**Re: Bromsgrove District Council Tree Preservation Order (N0.19) 2016 Tree/s  
on land at Plymouth Drive, Barnt Green**

On behalf of Mr David Courts of no. 1 Plymouth Drive, Barnt Green, please accept this letter as a formal **OBJECTION** to the above Tree Preservation Order. A copy of the Tree Preservation Order (TPO) has been forwarded to us (see Appendix 1).

**Summary of objection**

Drawing No: BDC TPO (19) 2016

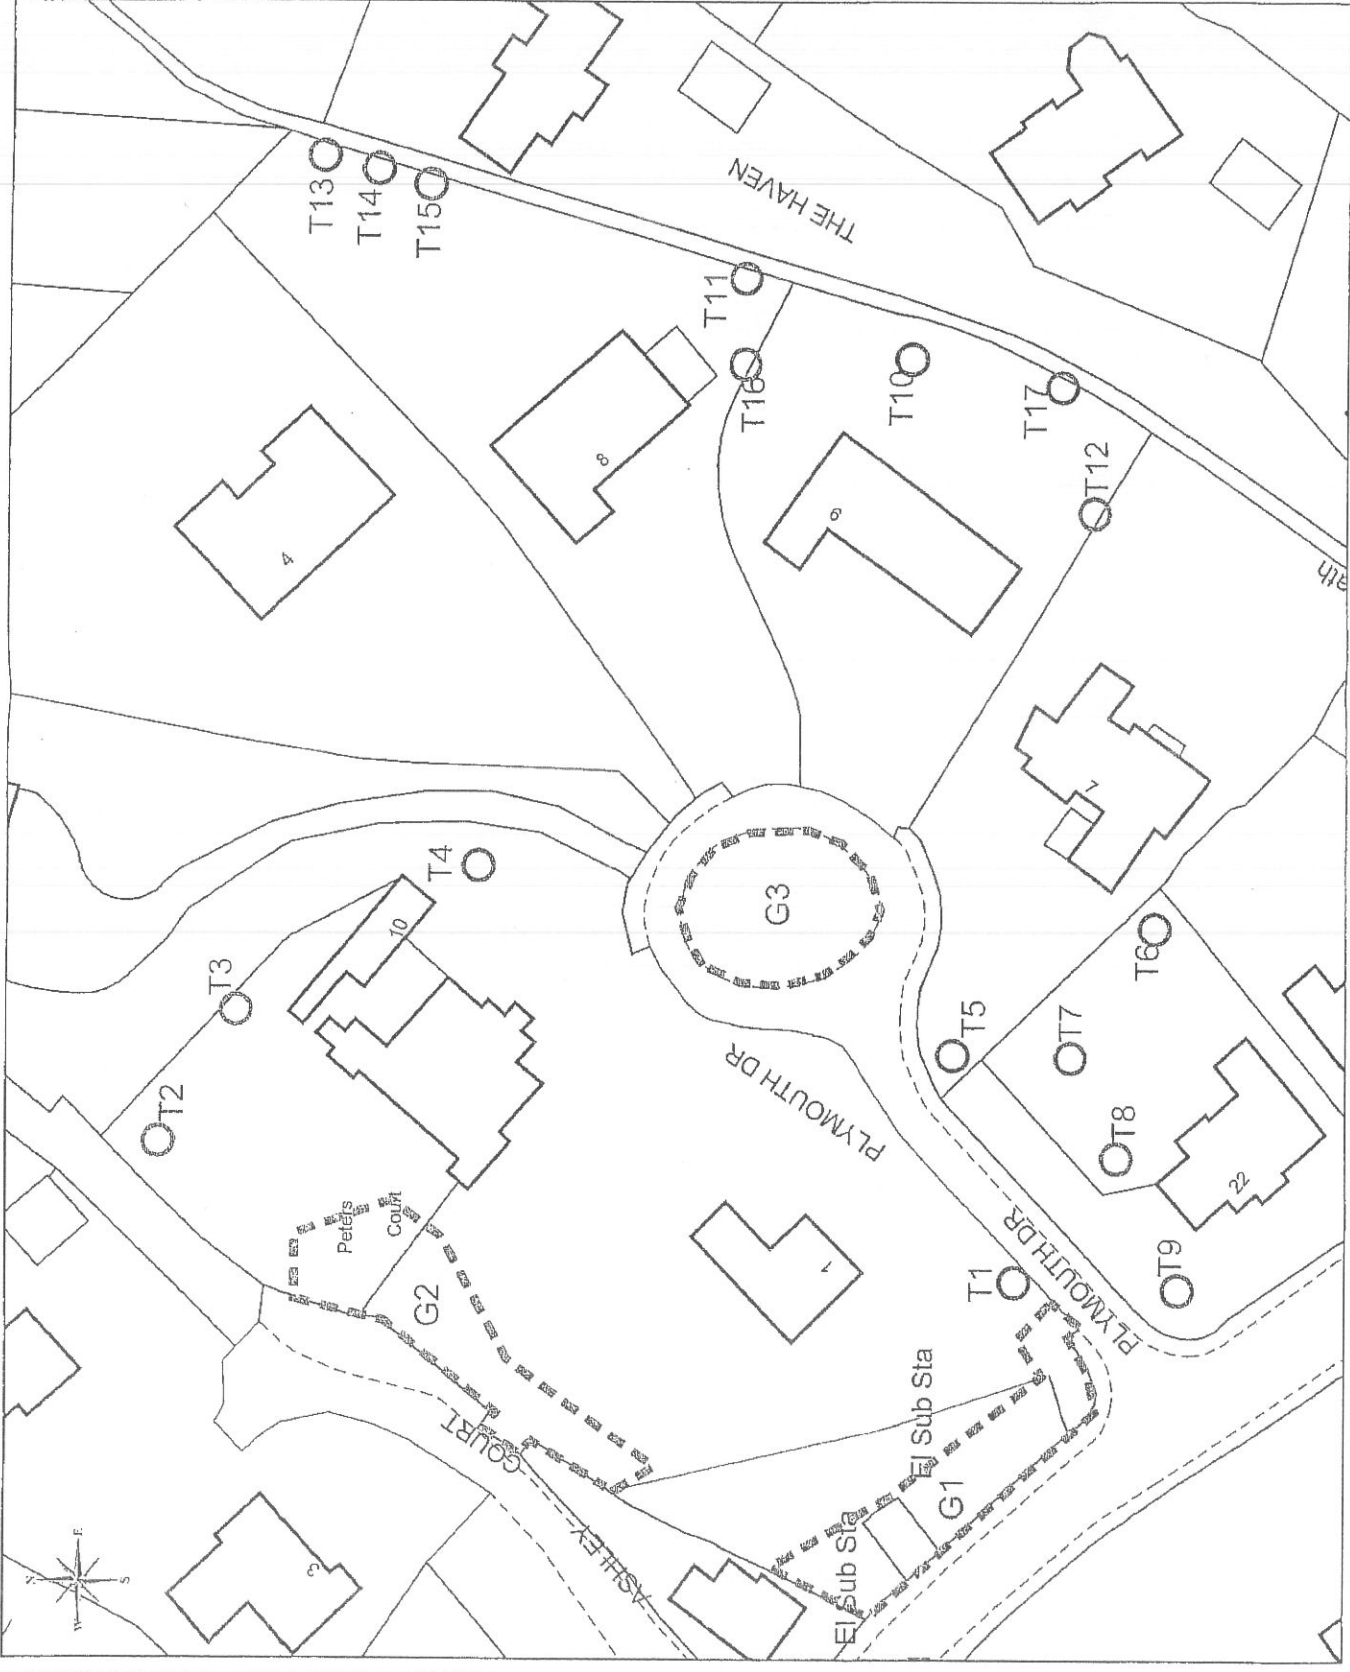
confusion over which trees are protected. Within G1, the Red Oak has a basal cavity, other defects and is of poor form and shape and was rated as being of low suitability for retention. One of the Sycamores (tree 4), the Oak (tree 5) and the Lawson Cypress G1, were all rated in the Marlow Consulting Ltd tree survey as being of low suitability for retention.

3.1.4 The first schedule identifies trees within Group G1 as 1 x Sycamore, 1 x Red Oak, 1 x Horse Chestnut, 1 x Oak. The area encompassed by G1 includes two Sycamores, so which one is protected? The area on the plan also includes a group of Lawson Cypress (G1 in the Marlow Consulting Ltd tree survey). As the plan typically takes precedence in respect of what is protected, it would suggest the Lawson Cypress and two Sycamores are protected but not listed in the first schedule.

3.1.5 The Town and Country Planning (Tree Preservation) (England) Regulations 2012, provides details of what should be included in the TPO. A template (see Appendix 5) for the first schedule is provided, which specifies how the trees within the different classifications within the TPO are to be specified. For groups, it clearly states that the number of trees of each species in the group should be listed, i.e. 2 Ash, 3 Birch, 3 Oak. Within the first schedule of this TPO the description for G2 is 'All trees with a stem diameter greater than 100mm at 1.5m'. **This doesn't conform to the 2012 regulations, is vague and inaccurate.** Trees within G2 include a tree (Sycamore – tree 7) identified in the Marlow Consulting Ltd tree survey as requiring to be felled due to its poor condition.

3.1.6 Trees on the property side of the groups G1 & G2 are barely visible from outside the site and as such don't meet the criteria, that is, if they were to be removed it would have a significant negative impact on the local environment and its enjoyment by the public.
